March 19, 2021

Re: Response to Peer Review Comments from GEC  
Lot 42 Mill St, Westwood, MA (Map: 28, Parcel: 013)

**Figure 1. Jurisdictional flood zones within the locus site. (FEMA, Map Number 25021C0178E, July 17, 2012)**

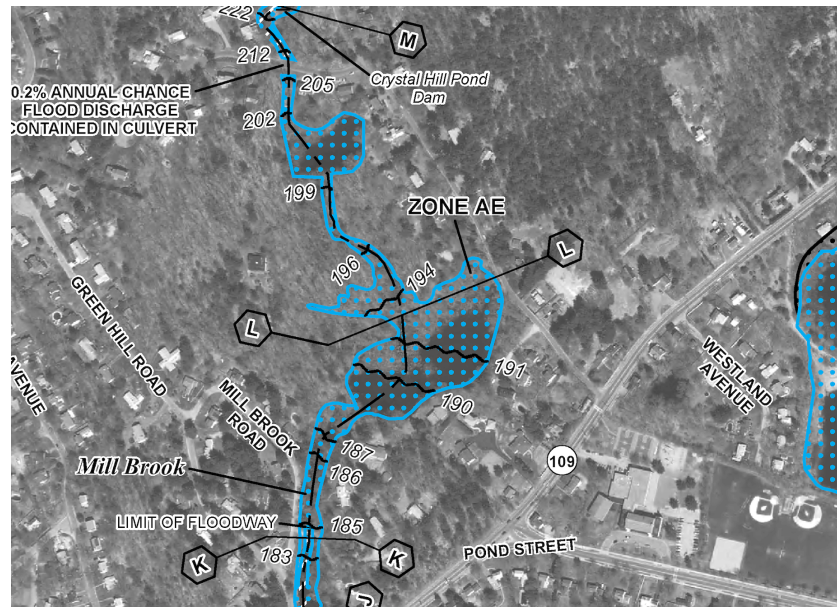
*“Attachment F is the latest FEMA flood map for the 100- and 500- year elevations from the MASS GIS system. Note that the entire site is within the 100 year flood plain including the house location. In fact the entire lot as shown is within the 100 year flood plain.”*

**According to 310 CMR 10.57(2)(a)3. States the following in regards to determining the boundary of floodplain:**

***3. The boundary of Bordering Land Subject to Flooding is the estimated maximum lateral extent of flood water which will theoretically result from the statistical 100-year frequency storm. Said boundary shall be that determined by reference to the most recently available flood profile data prepared for the community within which the work is proposed under the National Flood Insurance Program (NFIP, currently administered by the Federal Emergency Management Agency, successor to the U.S. Department of Housing and Urban Development). Said boundary, so determined, shall be presumed accurate. This presumption is rebuttable and may be overcome only by credible evidence from a registered professional engineer or other professional competent in such matters.***

**Below is a screenshot of the most recent FEMA FIRM map of the locus area (see attached full FIRM map. Flood Zone AE shown on this FIRM map is the jurisdictional floodplain in accordance with the Wetlands Protection Regulations. This floodplain has been correctly referenced on the submitted site plans.**
